Determination 2019/029

Regarding the compliance of a retaining wall and associated sitework at 18 Reeves Road, Pakuranga with Building Code Clause B1 Structure and whether a notice to fix should have been issued

Figure 2: Retaining wall and partial site plan (from the expert's report)

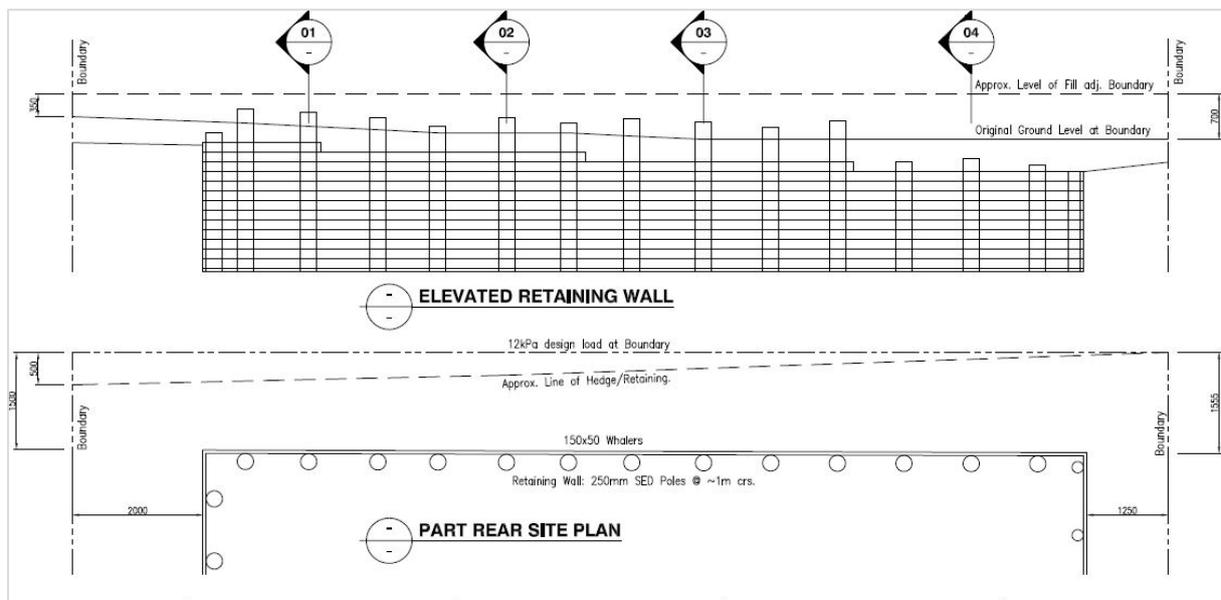
- 2.3 This soil cut is supported by a timber pole retaining wall comprising 250mm SED (small end diameter) poles in 400mm diameter concrete footings at an average of 1m centres, and with 150x50mm horizontal whalers between the poles. When the expert visited on 26 February 2019 the retained height was 1.95m at the wall's western end, dropping to 1.5m at the eastern end (refer Figure 2 below).

- Her surveyor had established that the retaining wall had been built 1.5m from the shared boundary, which was not in accordance with the consented plans (which show the wall 2m away). She said because the ground sloped up to the boundary, it was higher where the retaining wall was now sited and the wall might not be able to cope with the increased load.

- 5.6 The expert said he had “no issues” with the amended design and added:
- The retaining wall’s proximity to the shared boundary (ie 1.5m instead of 2m away) was not an issue as the amended design took this into account.

- 6.1.7 As the amended design is conservative – it applies a 12kPa surcharge behind the retaining wall instead of at the boundary – the expert considers the wall's siting closer to the boundary is not a concern. He also considers the loading imposed by fill on the applicant's property is no greater than this 12kPa surcharge.

Figure 3: Sketches showing cross section of retaining wall at eastern end. On left, as built; on the right, as designed (from the expert's report)

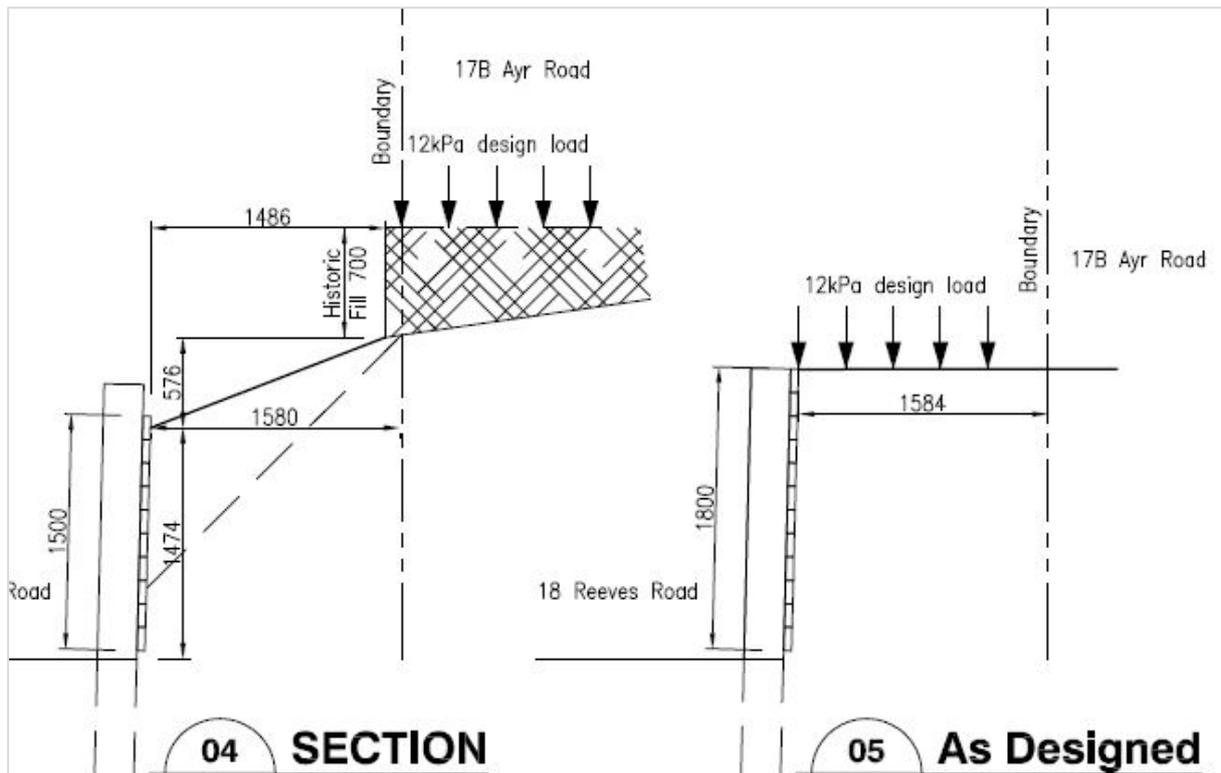
5.3 The expert’s report included a part site plan drawing. Figure 2 (refer page 3) shows a detail of this drawing and Figure 3 shows another, being one of the cross-sections (at the wall’s eastern end) and the expert’s sketch of the amended design to illustrate where the 12kPA load was applied.

- This design was conservative as the designers had applied the 12kPa surcharge immediately behind the wall instead of at the shared boundary, and the loading imposed by non-engineered fill on the applicant’s property was no greater than this surcharge.

- The amended design and drawings showed a maximum height of 1.8m but the associated documentation referred to 2m. The as-built wall exceeded 1.8m at its western end but this was not a concern, as corners were self-propping.

- 5.7 In the expert’s view the retaining wall should be completed by adding whalers behind the over-height poles, and then backfilled so the original boundary ground level (the ground surrounding the base of the tree trunks) was satisfactorily

- 6.1.6 The expert has assessed the retaining wall as designed and built. In his view it will comply with the requirements of Clause B1 when completed and backfilled so it supports the original boundary ground level, as described in paragraph 5.7. The expert also inspected the applicant's property and agreed with the findings of other investigations: that there was no evidence of any settlement that could be attributed to the owner's excavation.

- 6.1.9 Therefore, I conclude that the sitework and retaining wall, when completed as specified, will meet the requirements of Clause B1 for structural stability (which for the retaining wall includes supporting the land behind it) and to avoid the likelihood of damage to other property (ie Clause B1.3.6(b)).
